ADDENDUM NUMBER 1

- 1.01 DATE: April 7, 2015
- 1.02 PROJECT: Interior Renovations to the Mimosa - G Residence
Ramapo College of New Jersey
- 1.03 SNS PROJECT NUMBER: 4698G

INTERIOR RENOVATIONS
AT THE
MIMOSA - G RESIDENCE

Cert./Lic. No. AI 109740
Date 01-09-15 Scale AS NOTED
Drawn By DP Checked By DP
Dwg. Title
**ENLARGED PLAN, MILLWORK,
DETAILS & EQUIP. SCHEDULE**
Work Order No. Dwg. No.

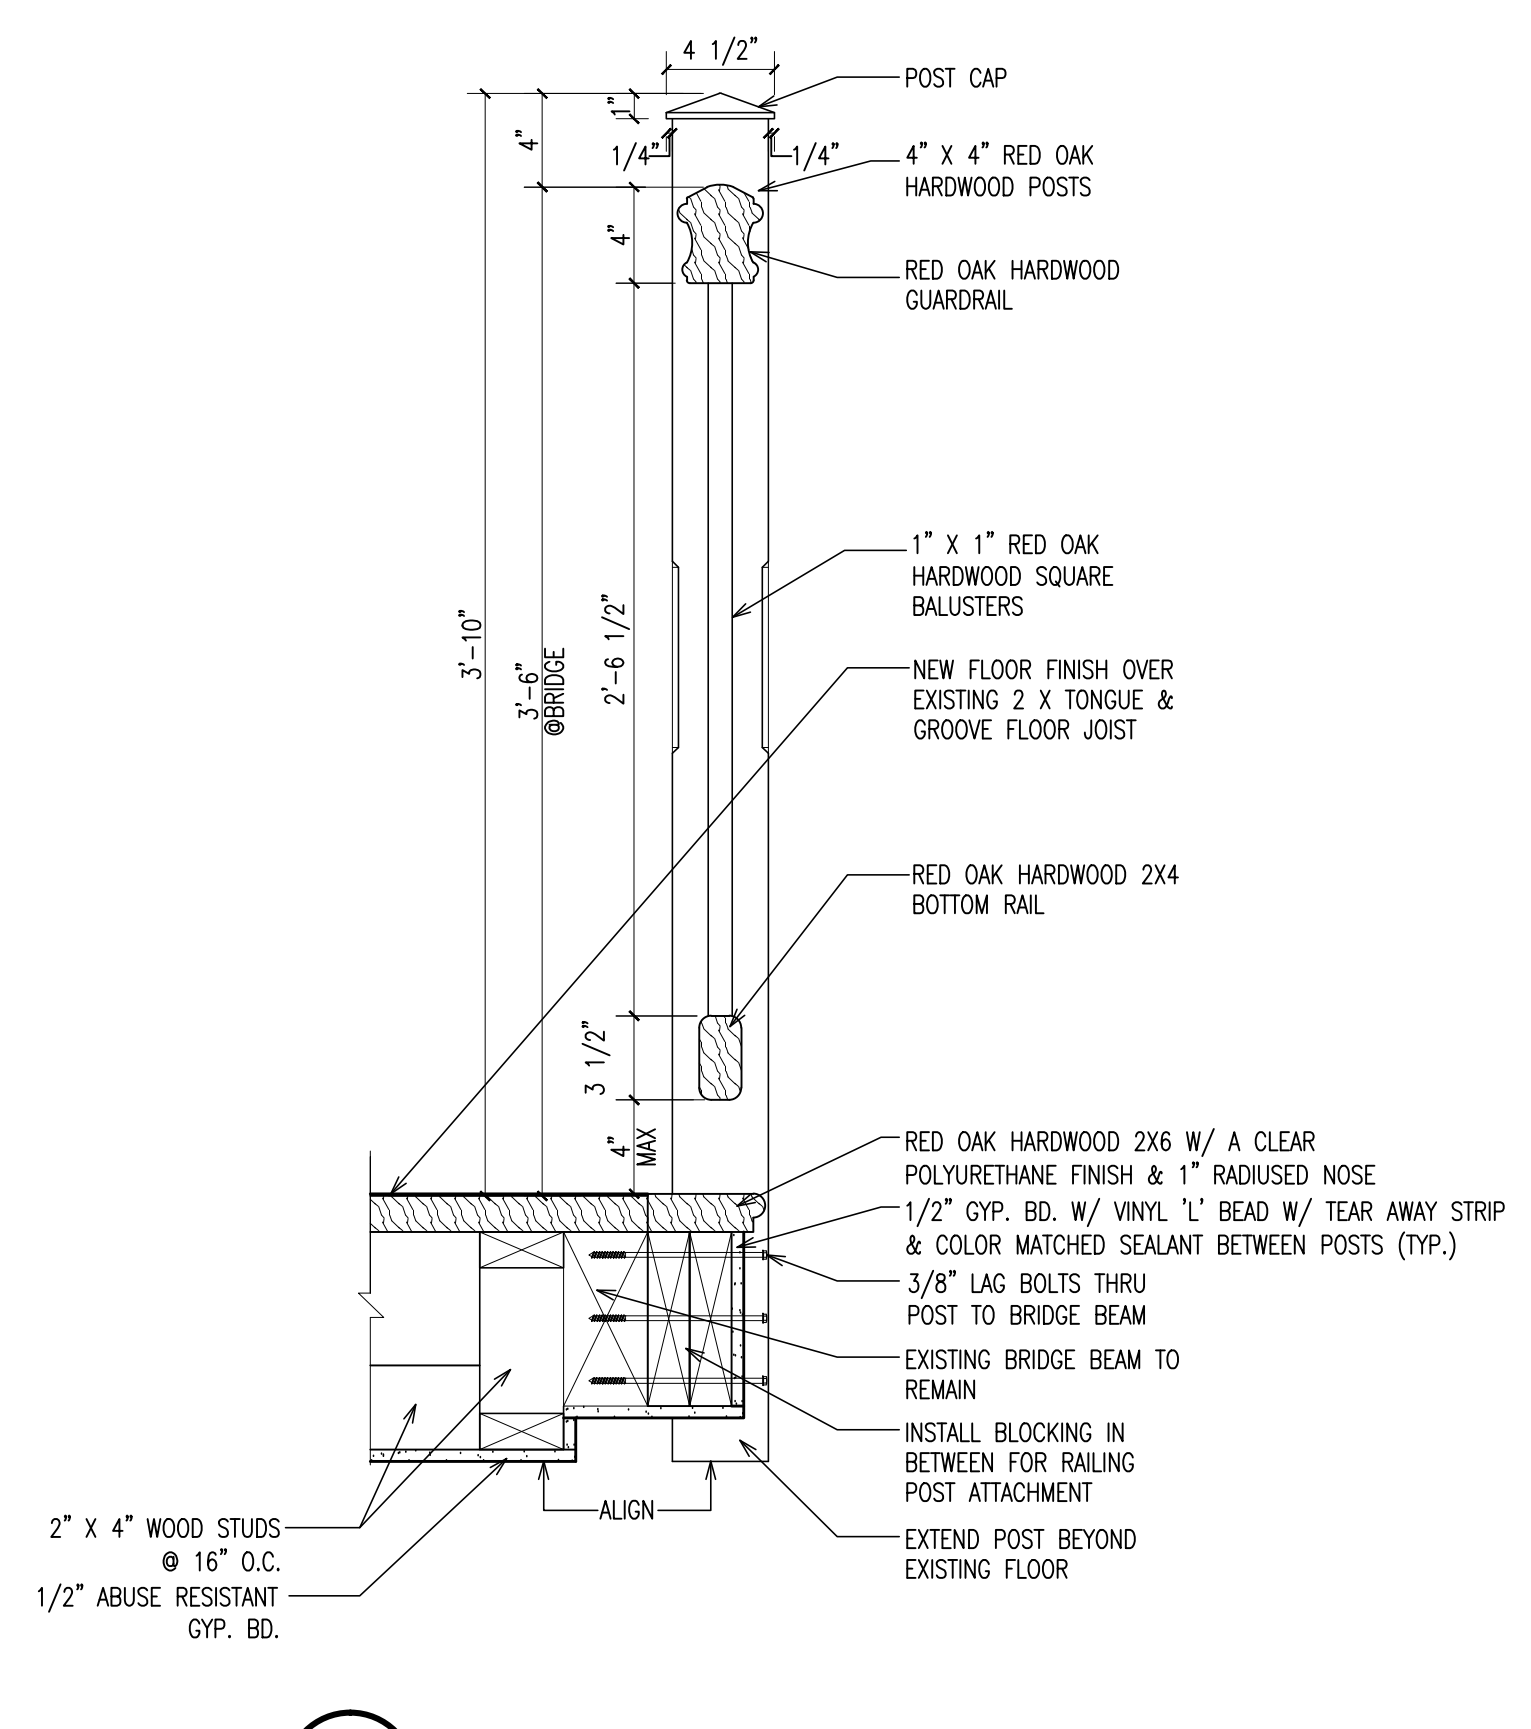
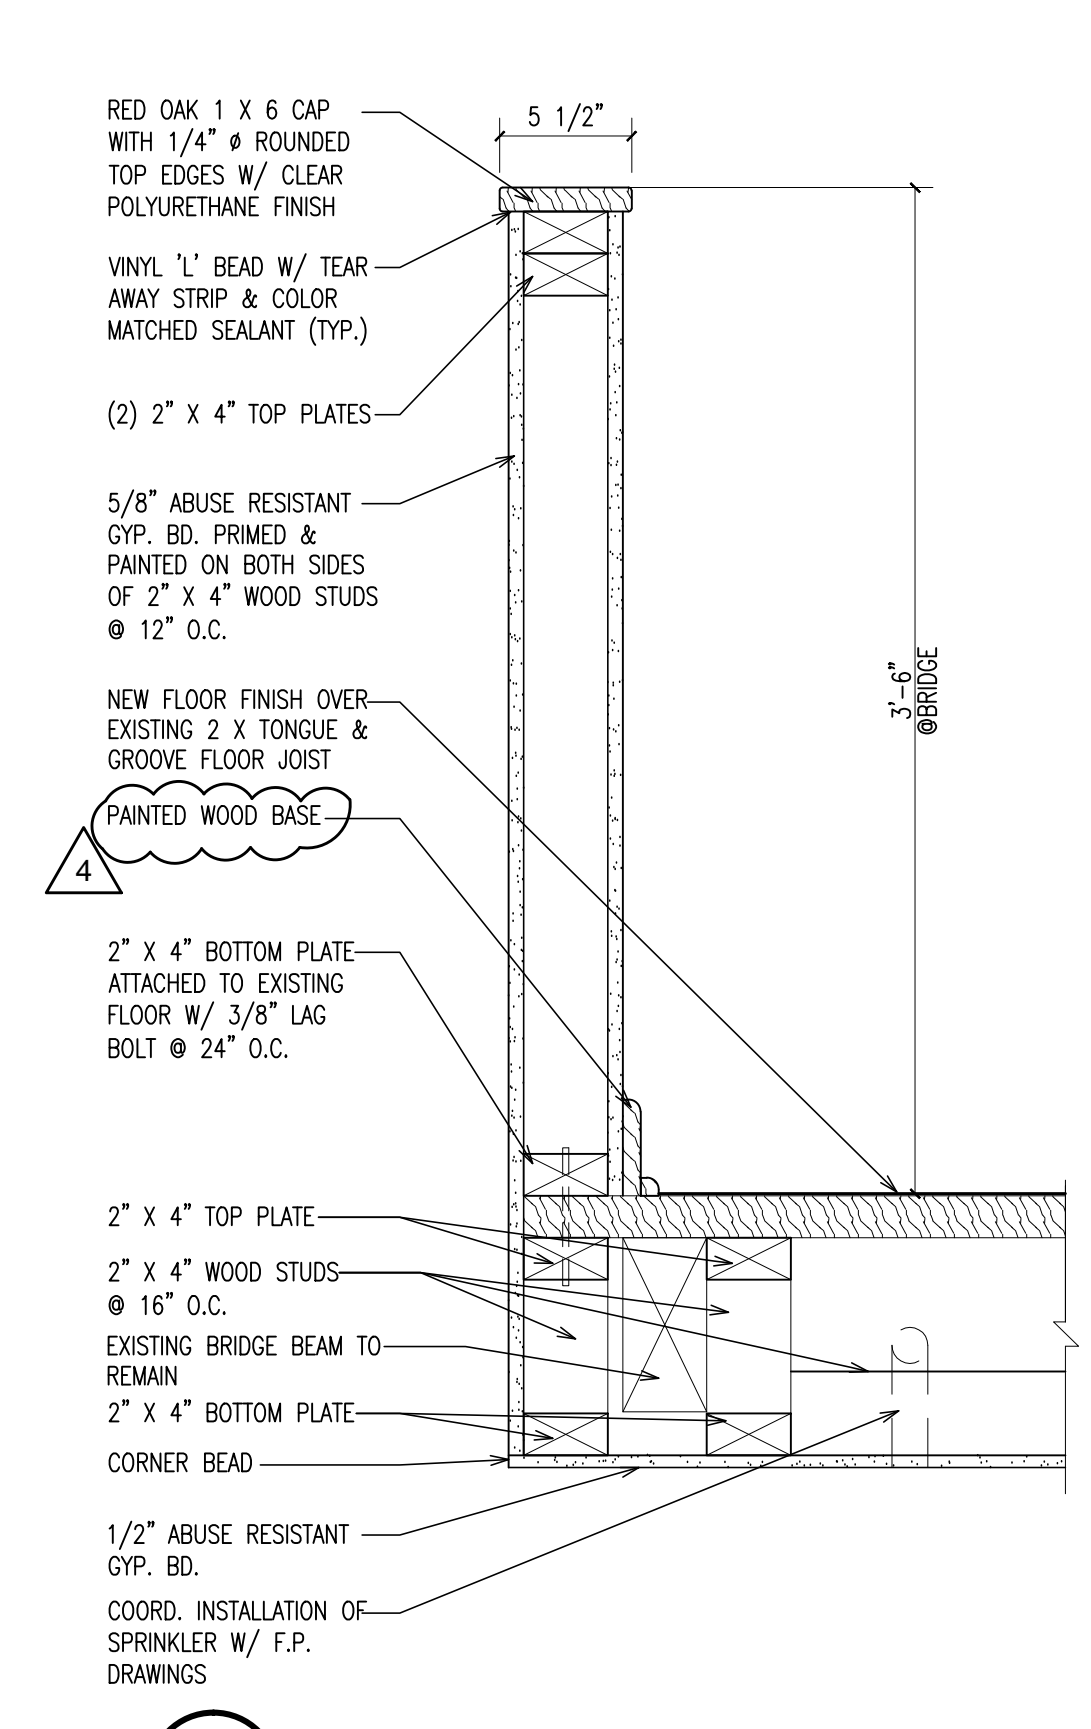
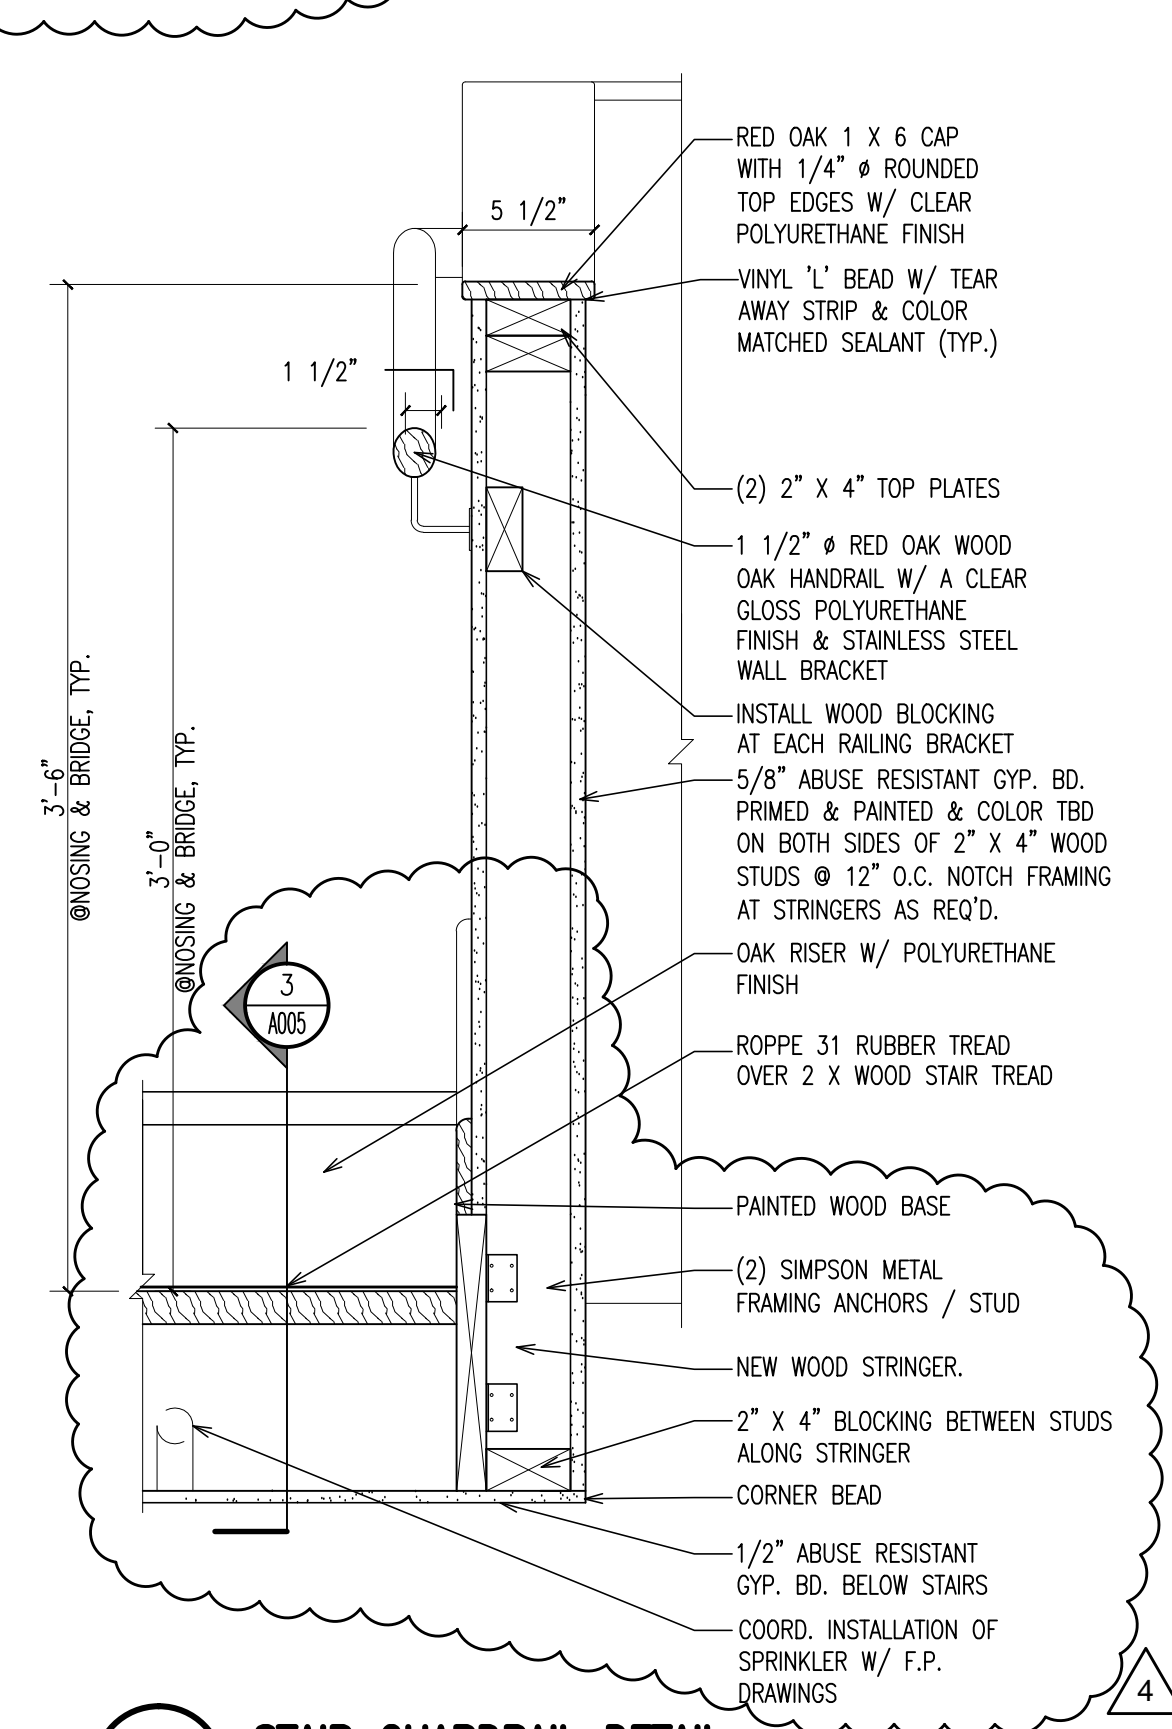
- 4.4. Insulation Notes: first note has been revised.
- 5. DRAWING A004, ENLARGED PLAN, MILLWORK, DETAILS & EQUIP. SCHEDULE:
 - 5.1. Equipment Schedule:

- 5.1.1. Mark & Description #29 have been removed (Vinyl Composite Tile Flooring).
 - 5.1.2. Mark #28, has been revised, it is no longer an alternate in kitchen area.

- 5.2. Enlarged Bathroom & Kitchen Plan: Mark #29 has been replaced with Mark #28.
 - 5.3. Cabinet Sections #7, #8 & Vanity Section #9: VCT finish flooring note has been replaced with” Linoleum finish flooring”.
